**REZONING PLAN
WOODSIDE FALLS PATIO HOMES
FOR FIRSTMARK DEVELOPMENT CORPORATION
BY DPR ASSOCIATES INC. LANDSCAPE ARCHITECTS**

SHEET 1 OF 2

SUBJECT: Administrative Approval for Petition #86-77(c). A change to note # 4.

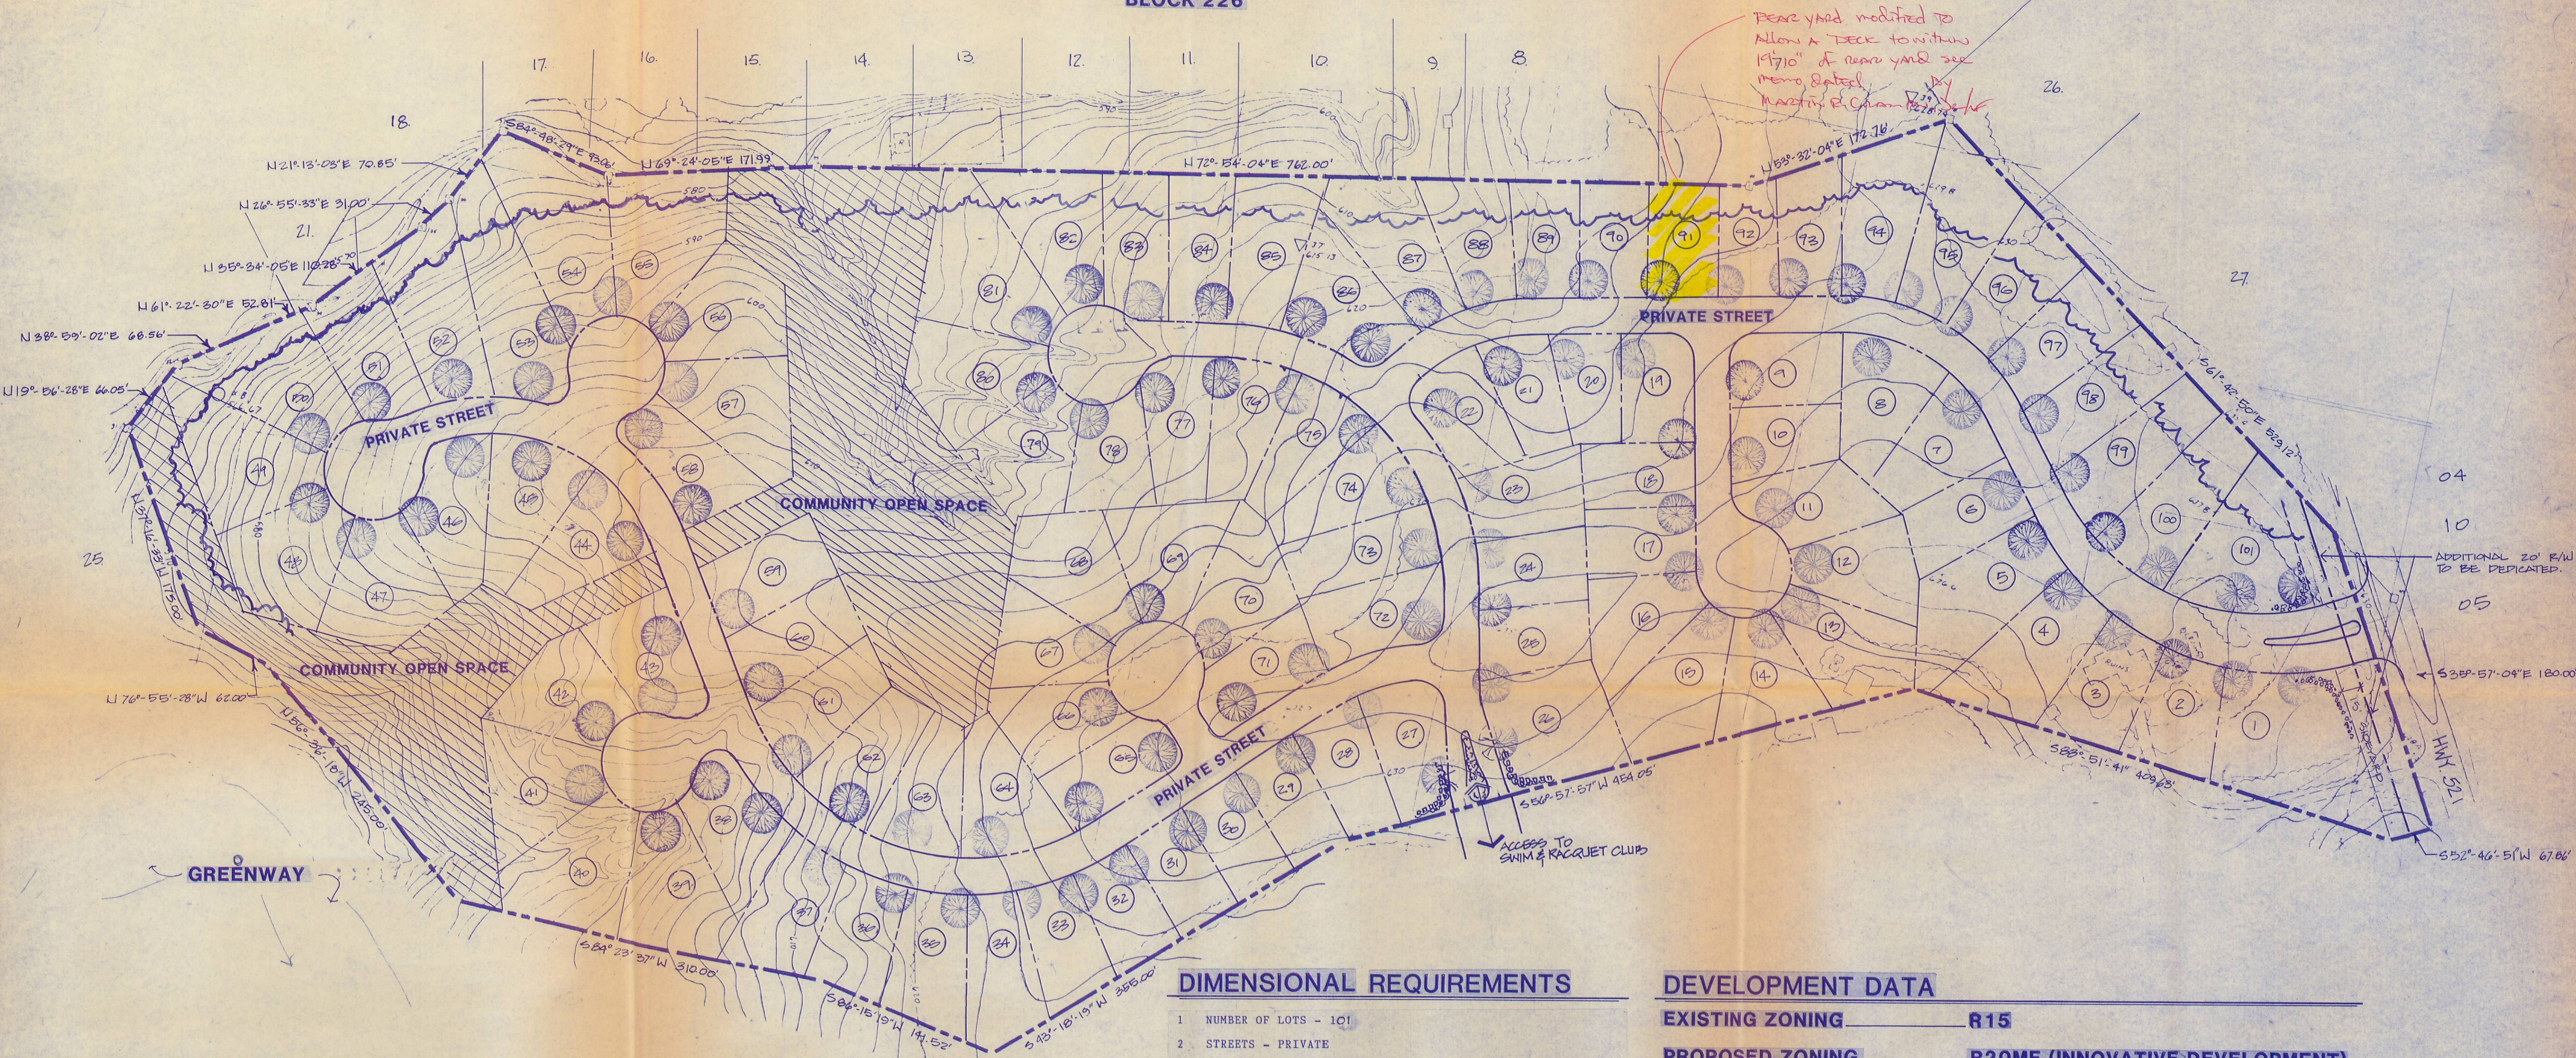
COMM NO: 86027 REVISIONS: 12-1-84 REDUCED TOTAL NUMBER OF UNITS TO 101, REVISED LOT LAYOUT & ADDED NOTE # 8
12-15-88 REV. NOTE # 4 OF PERFORMANCE STANDARDS
1-19-89 REVISED NOTE # 4 OF PERFORMANCE STANDARDS

The attached site plan has been modified to change the wording of note number four. The note has been modified to require only two off street parking spaces for lots that front on a cul-de-sac. The lots that do not front on a cul-de-sac must provide three off street parking spaces. Since these changes do not represent an intensification of the site or reduce the required yards I am administratively approving this plan. Please use it when evaluating requests for building permits.

- LOTS FACING ON A CUL-DE-SAC ARE TO HAVE A MINIMUM OF 2 PARKING SPACES EACH. ALL OTHER LOTS SHALL HAVE 3 PARKING SPACES MINIMUM PER LOT. THESE REQUIRED PARKING SPACES MUST BE LOCATED ON EACH INDIVIDUAL LOT.
